UNITED STATES PATENT AND TRADEMARK OFFICE

APPLICATION NO.	FILING DATE	FIRST NAMED INVENTOR	ATTORNEY DOCKET NO.	CONFIRMATION NO.
09/815,670	03/23/2001	Hiroshi Yoshida	09792909-4825	5768

Office Action Summary	Application N .	Applicant(s)
	09/815,670	YOSHIDA ET AL.
	Examiner	Art Unit
	Quyen P. Leung	2828

DETAILED ACTION

FIG. 15

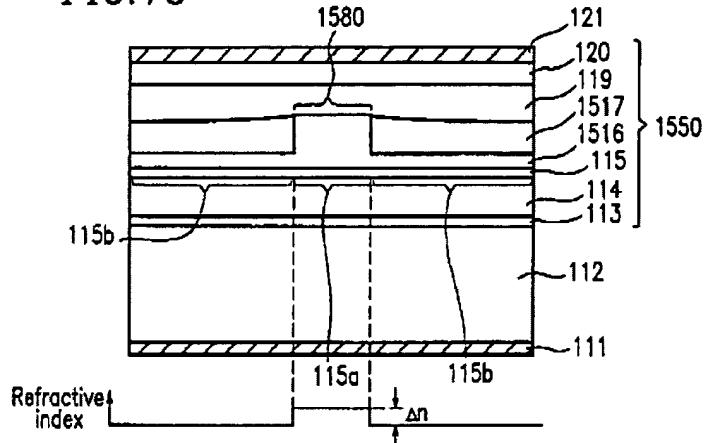
4. Claims 1, 3-9, 11-17, 19-24 are rejected under 35 U.S.C. 102(b) as being anticipated by Kume et al (5,923,690). Kume teaches the claimed invention. For example, note figure 15 which illustrates a semiconductor laser light emitting device comprising a stacked film composed of a stack of group III nitride semiconductor films (1550) each containing at least one kind selected from aluminum, gallium, indium and boron, wherein an upper portion (1516) of the stacked film is formed into a ridge-like stripe (1580), to form a current injection region, a current non-injection region (1517)

injection region (1517) is

made from a material ($\text{Al}_{x=0.25}\text{Ga}_{1-x}\text{N}$) expressed by a chemical formula AlGaN, the improvement wherein the component "x" of Al is specified at a value in a range of $0.15 < x < 0.30$, so that the semiconductor laser light emitting device is configured as a weak index type pulsation semiconductor laser light emitting device.

FIG. 17

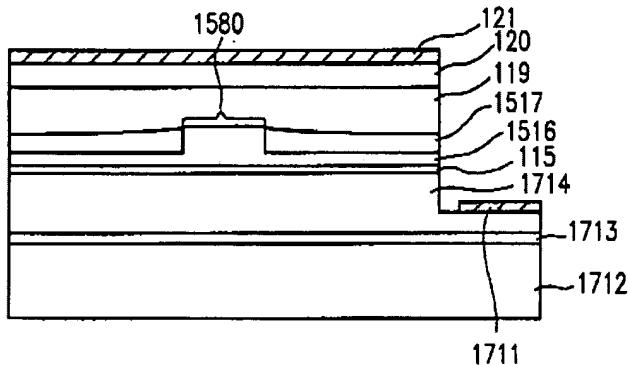
Note also figure 17.

Kume et al teaches the same ranges as claimed by applicant, see col. 15 lines 24-26 and lines 50-55. Furthermore, applicant discusses the device being configured as an index-guided type (see col. 16 line 20), as a gain-guided type (see col. 16 line 35)

and as a weak index type (see col. 16 lines 46-
